Re: Turkey Point Units 3 & 4  
Docket Nos. 50-250 & 50-251  
Disposal of Powdex Resins

# TURKEY POINT PLANT SHRIMP PONDS

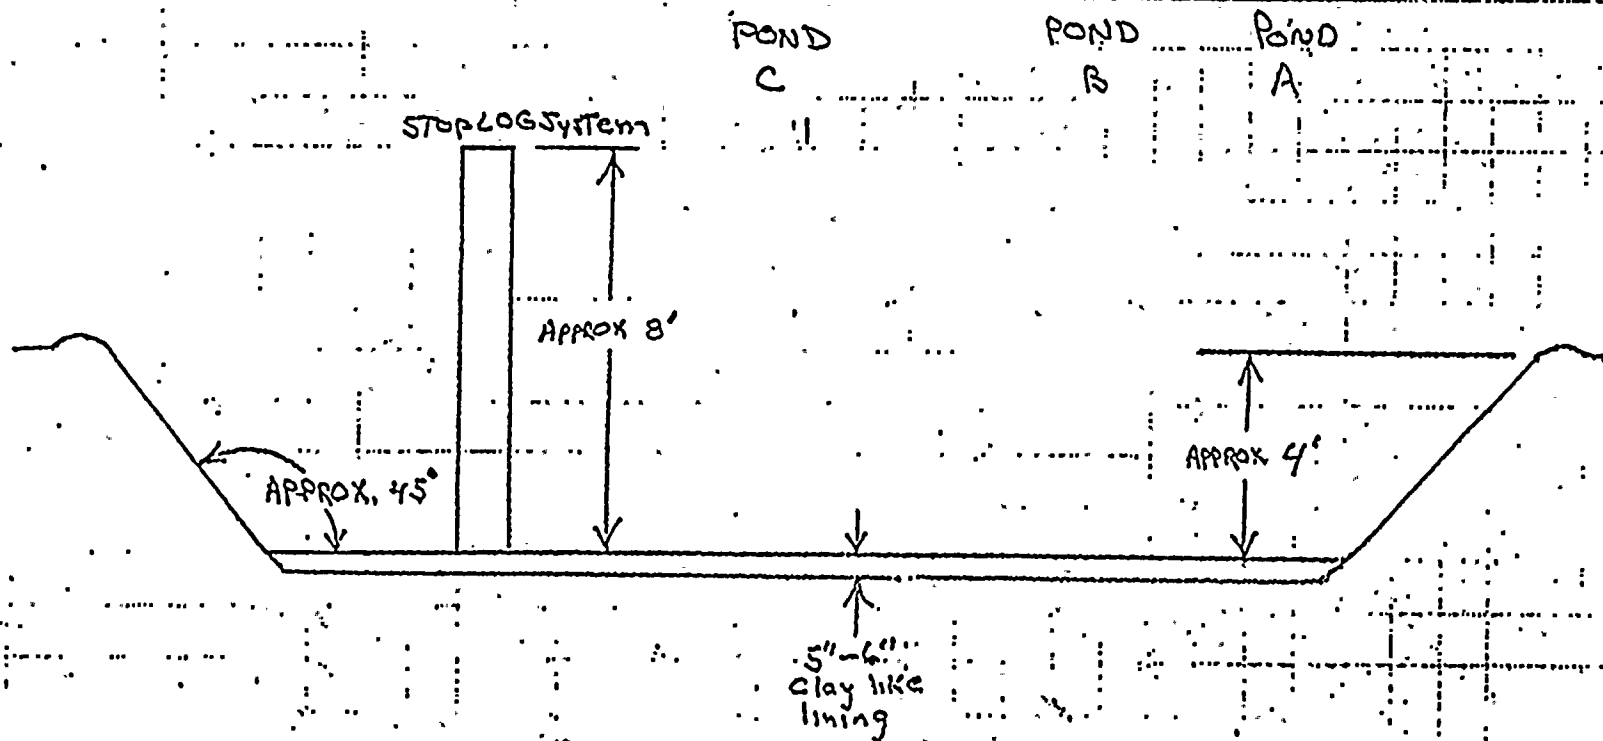
As we discussed over the telephone about two weeks ago regarding the steam generator repair at Turkey Point Plant Units 3 and 4 (Docket 50 - 250 and 50 - 251), Florida Power & Light Company is planning on site disposal of Powdex resins from the condensate polishing demineralizer. A discussion of the demineralizer operation is included in Section 3.2, pages 6-7 (copy attached) of the Biological Assessment and Section 4.3.3, pages 4-18 and 4-19 (copy attached) of the Final Environmental Statement. As indicated in both these discussions, the resins will be monitored for radioactivity and, if within the Nuclear Regulatory Commission limits for unrestricted disposal, they will be disposed of in "shrimp ponds" B and C (see attached map and sketch). Thus for all practical purposes, the resins will not be radioactive.

Based on calculations by FPL, we feel that the two designated ponds could contain an amount of material for nearly 30 years of polisher operation. Originally when the ponds were built and first operated in the early 1970's, they held water but due to cracking of the clay liners on the bottom and aging of the vinyl liner on the sides, these ponds no longer hold water but would effectively contain the resins.

After reviewing the information provided, including the report by Dr. Kunin, we agree that there would be no adverse impact to the American crocodile or adversely impact its Critical Habitat.
